ADDENDUM NO. 3

February 6, 2023

**SOLON ROBINSON ELEMENTARY SCHOOL ADDITIONS,
RENOVATIONS, AND RELATED WORK
Crown Point, IN 46307**

PLAN DETAIL

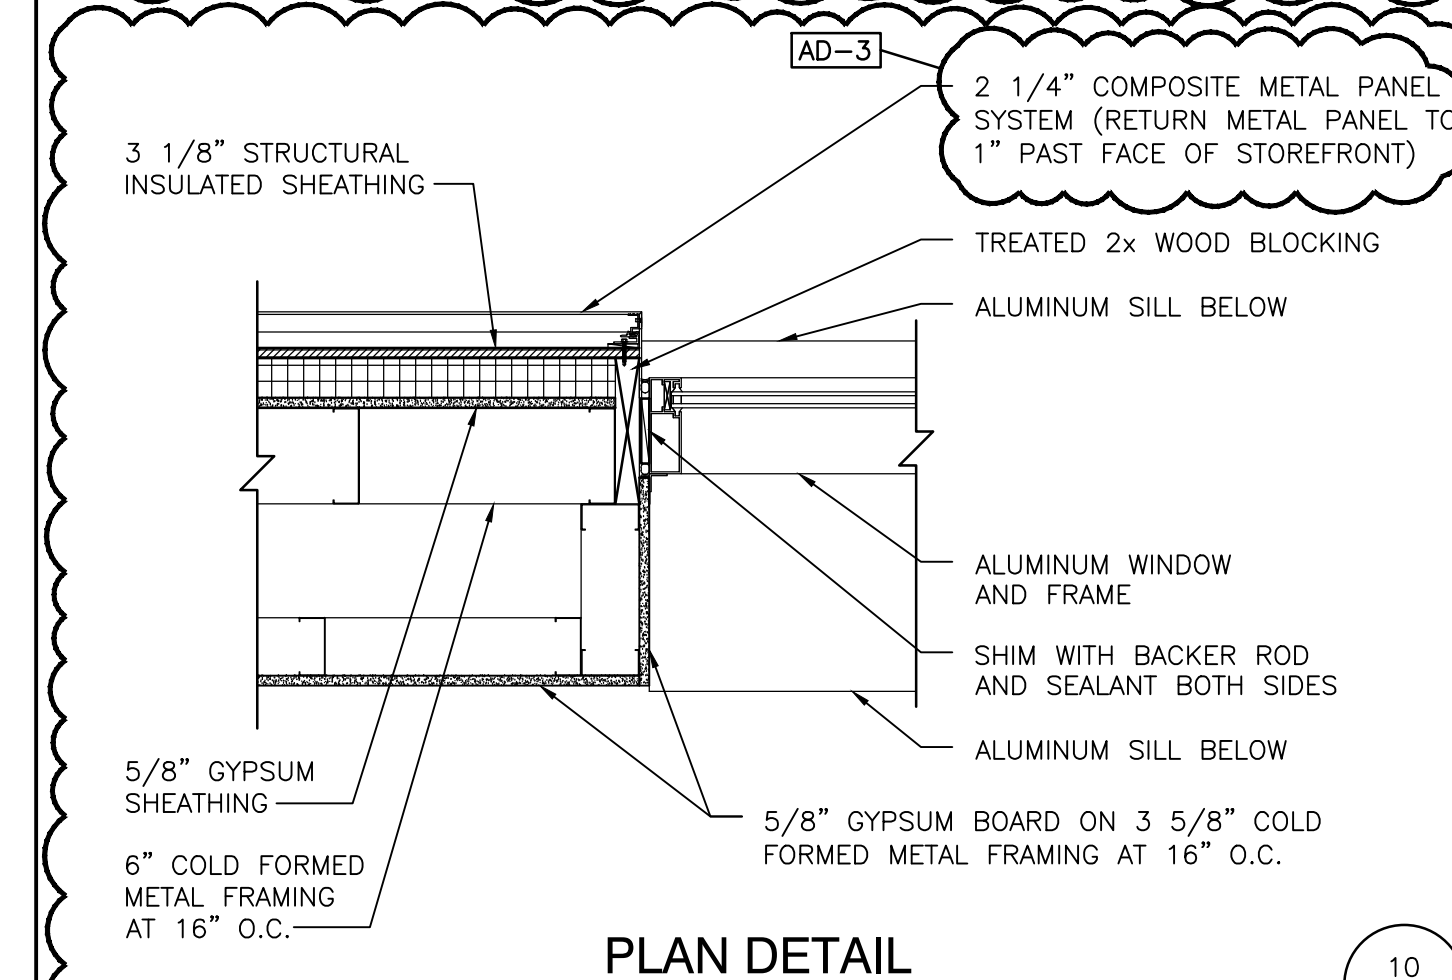
- A. Add new Plan Detail 11.

**TYPICAL EXTERIOR MASONRY WALL
CONSTRUCTION DETAIL**
SCALE: AS INDICATED

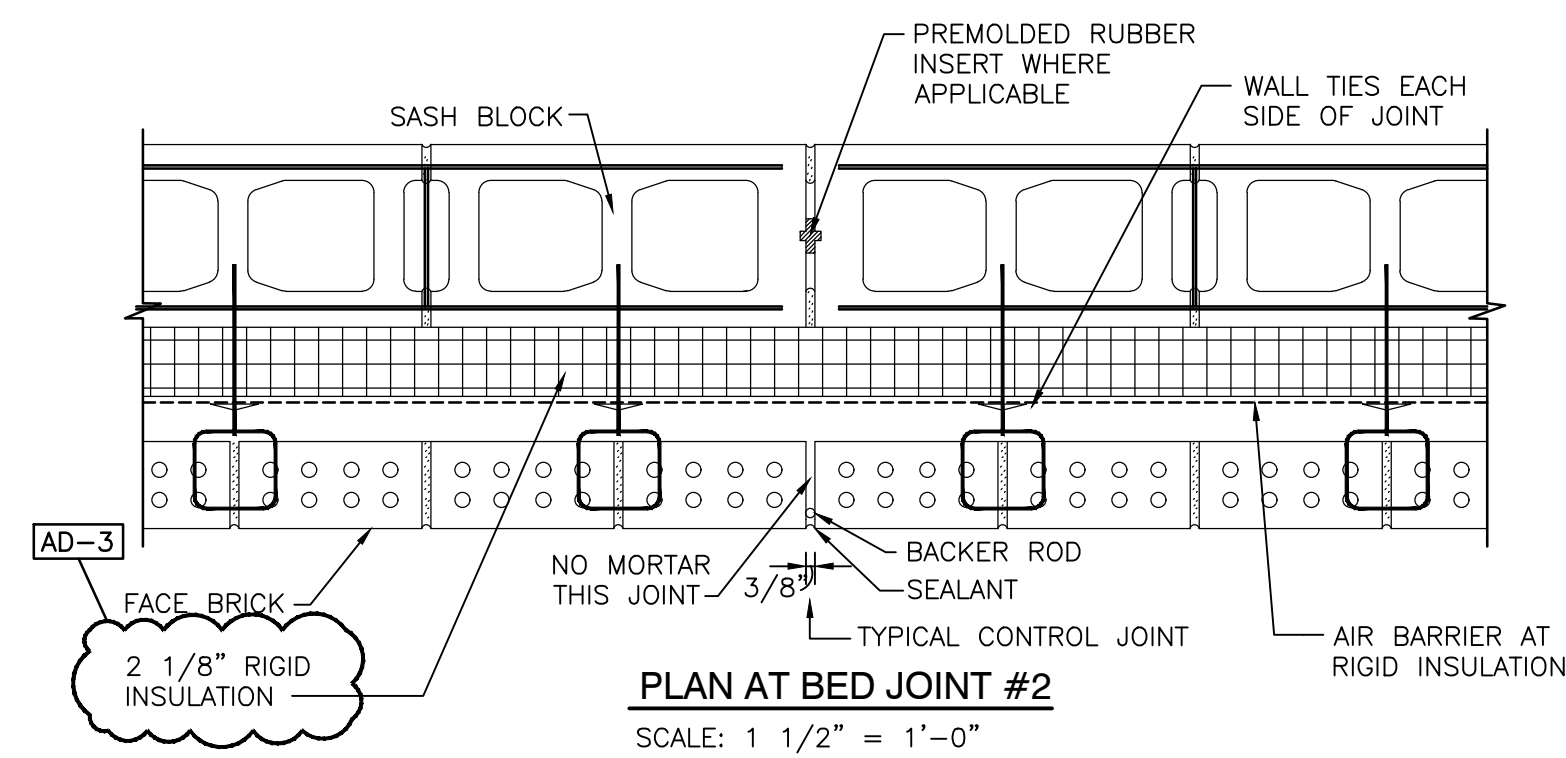
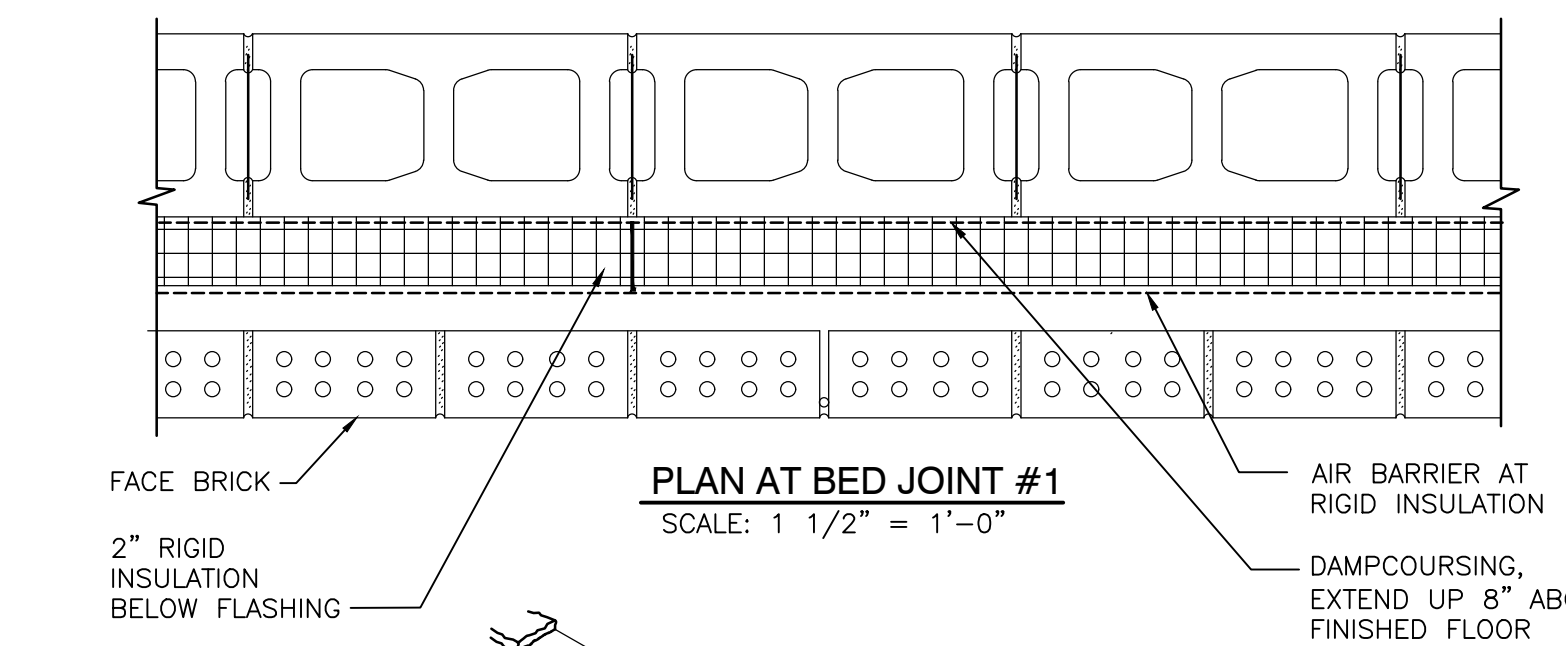
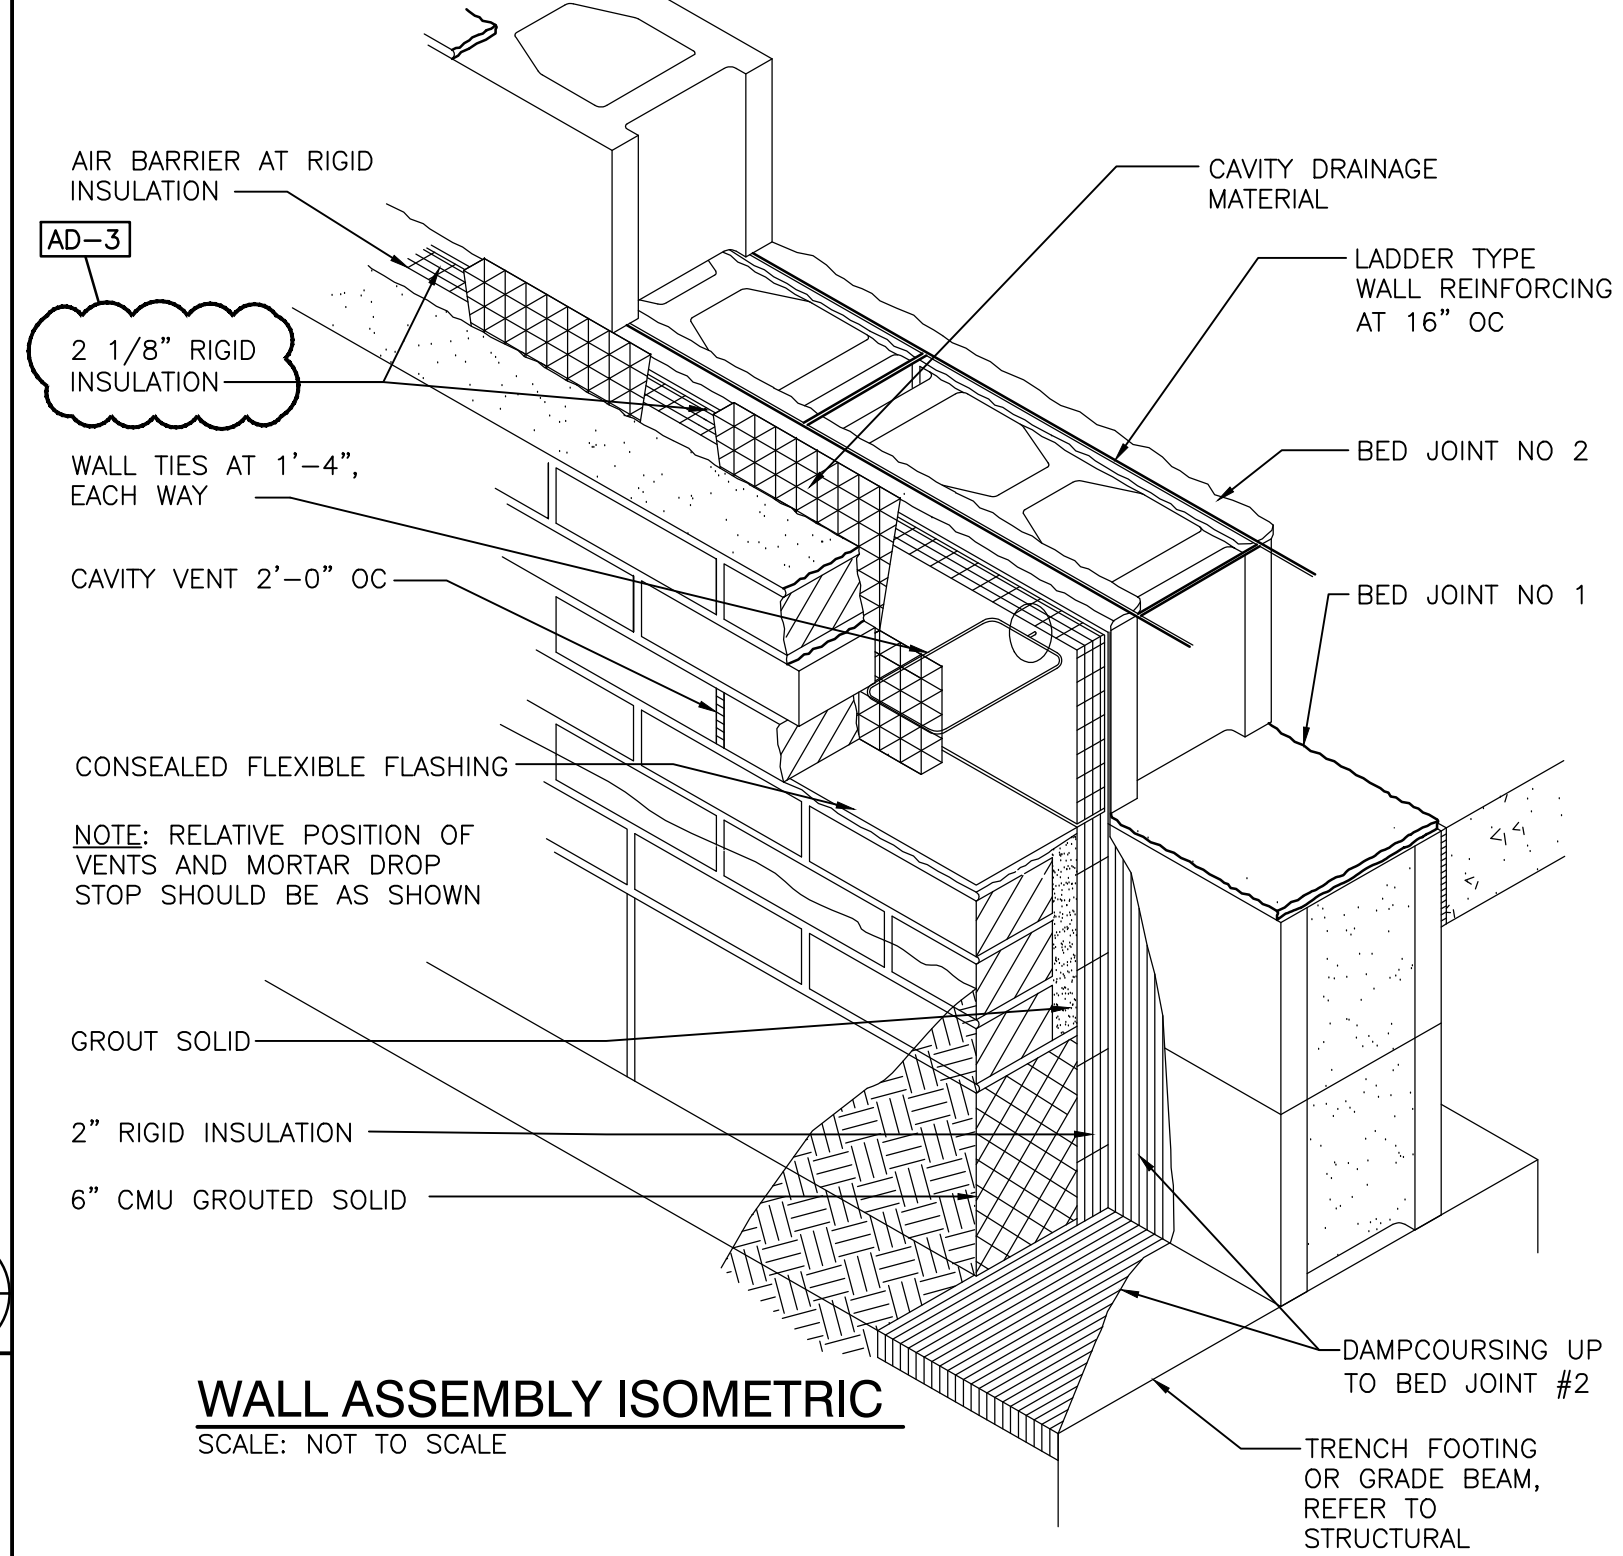
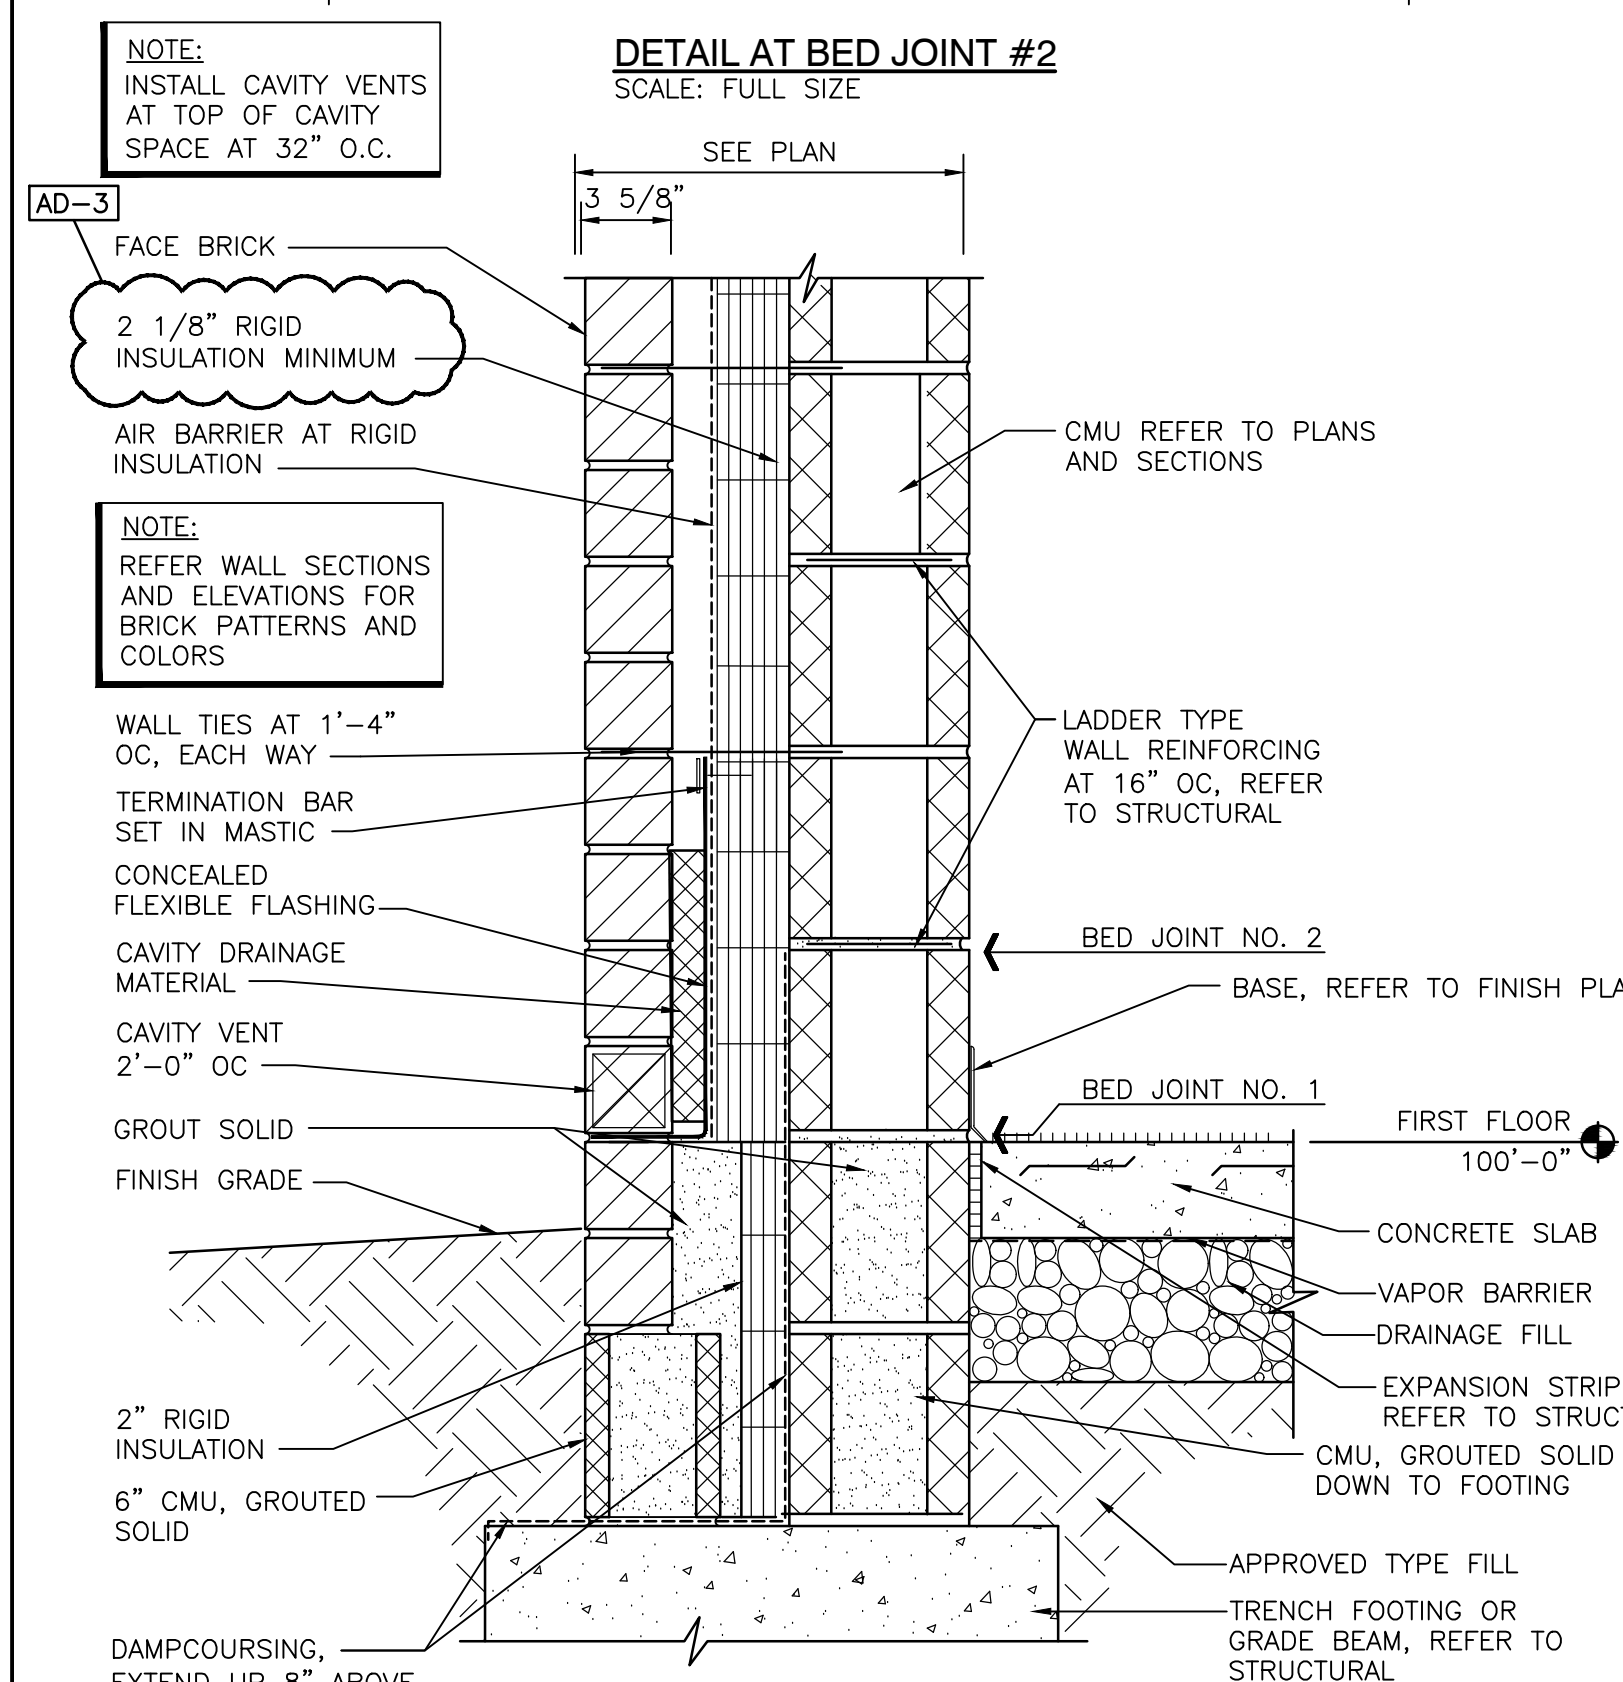
- A. Typical Exterior Masonry Wall Construction Detail 1: Change "3" rigid insulation" to "2 1/8" rigid insulation".
